# SERVICE BULLETIN

No. 222A

Piper Aircraft Corporation

- SUBJECT:** Removal of Restriction to Air Speed Limits  
(Replacement of Stabilator Torque Tube)
- MODELS AFFECTED:** PA-30 Twin Comanches, Serials 30-1 to 30-482 incl., 30-484 to 30-491 incl., 30-493, 30-494, 30-496 to 30-502 incl., 30-504, 30-505, 30-507 to 30-565 incl.
- NOTE:** Serial Numbers 30-483, 30-492, 30-495, 30-503 and 30-506 have been modified at the factory and require only removal of placard and temporary supplement to flight manual for compliance.
- COMPLIANCE DATE:** Prior to but not later than 10 hours of operation after receipt of stabilator torque tube.

STABILATOR TORQUE TUBE REPLACEMENT	
SKETCH "A"	KIT 756 827
PIPER AIRCRAFT CORPORATION	
LOCK HAVEN, PENNSYLVANIA

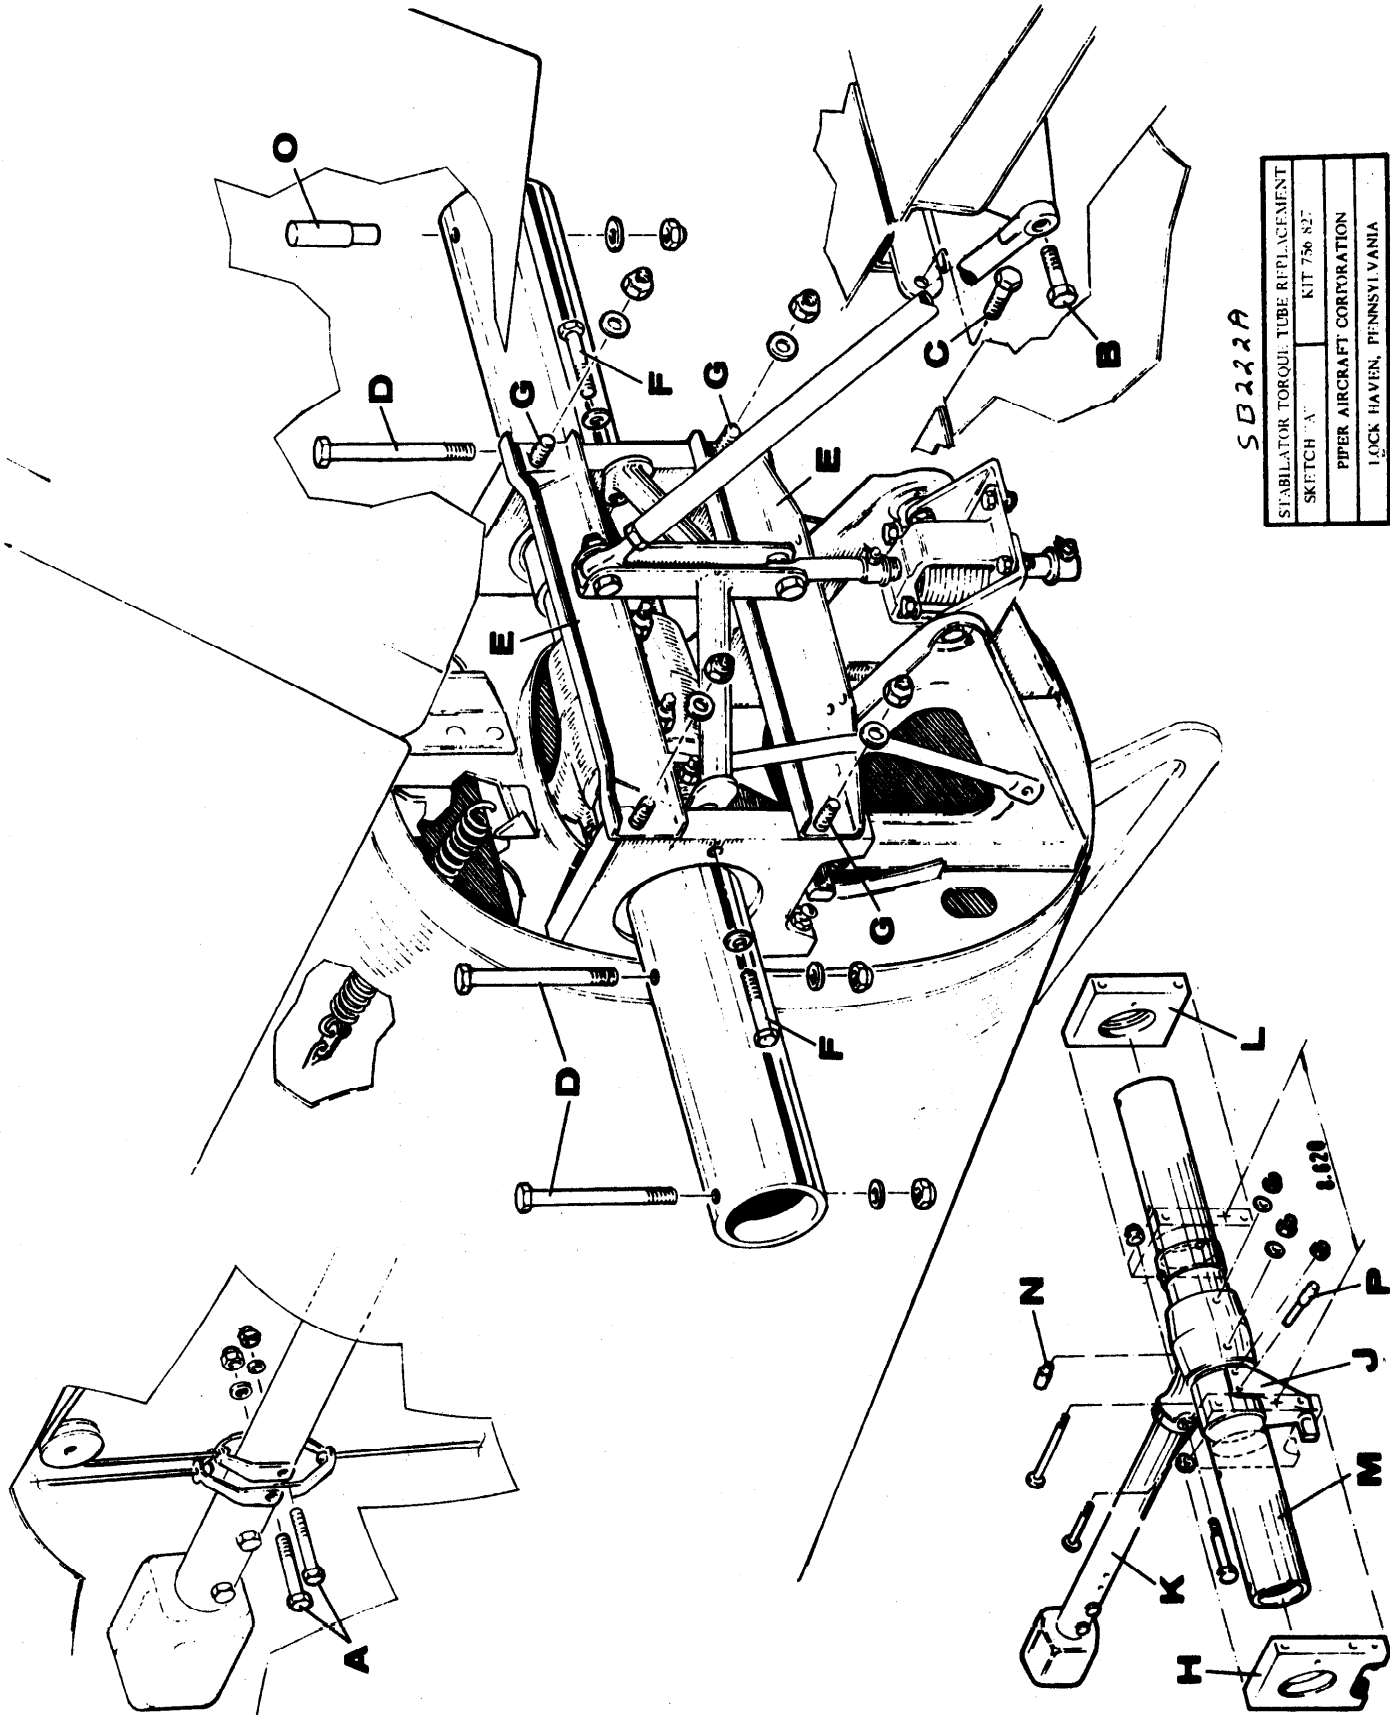
It has been determined that a stabilator torque tube, part number 22655-07, of heavier wall thickness will eliminate this vibration.

A new stabilator torque tube of heavier wall thickness will be provided to the owners of these aircraft as a replacement on a no charge basis.

16. Install counterbalance arm assembly on new stabilator torque tube, part number 22655-07. Note position in View B. Item M.

Holes drilled in the torque tube assembly are undersize and will be line-reamed on assembly. Since the holes in counterbalance arm assembly and stabilator fittings have already been

reamed, a special locating pin, part number 25034-00 is included with each torque tube to insure proper fit of these assemblies. Item N.

NOTE: Pin part no. 25034-00, Item N is larger in diameter than pin 25034-02, Item P.

When counterbalance arm is in position, insert locating pin, part number 25034-00 in one hole until the shoulder bottoms on the torque tube.

Ream the other hole in the tube to .3120 to .3130. Insert bolt in reamed hole before removing locating pin to ream the second hole.

Holes drilled in the torque tube assembly are undersize and will be line reamed on assembly. Since the holes in stop assembly have already been reamed, a special locating pin, part no. 25034-02, is included with each torque tube to insure proper fit of these assemblies. Item P.

When stop is in position, insert locating pin, part no. 25034-02, in one hole until the shoulder bottoms on the torque tube.

Ream the other hole in the tube to .2465 to .2475. Insert bolt in reamed hole before removing locating pin to ream the second hole.

Shims, part no. 81262-72, should be installed with bearing blocks in same position as when removed to maintain a dimension of 8.620 shown in View C.

19. Reinstall torque tube assembly on aircraft in reverse order of disassembly.
20. Install stabilators and bolt the rear spar. Insert locating pin in same manner as previously used in one hole on either stabilator. Ream the other hole to .3120 to .3130 and install bolt. Item O.
